DOCUMENT CHANGE REQUEST

DCR number 154	Changes required for: General	Originator: S Thacker
Date: 2005/03/30	Date sent: 2005/03/30	Organisation: ESA/ESTEC
Status: IMPLEMENTED

Title:	Transistors Low Power NPN, based on type 2N2484		
Number:	5201/001	Issue:	2

ESCC Detail Specification No. 5201/001

1.6.1 Metal Can Package (TO-18) - 3 lead

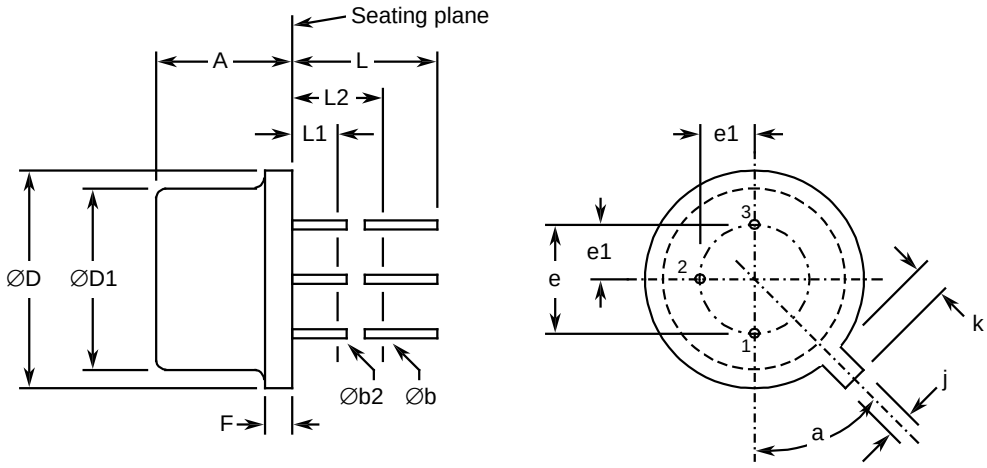
7. Para 4.4.1 Case requirements for Variants 01 & 02 corrected to reflect a TO-18 metal can.
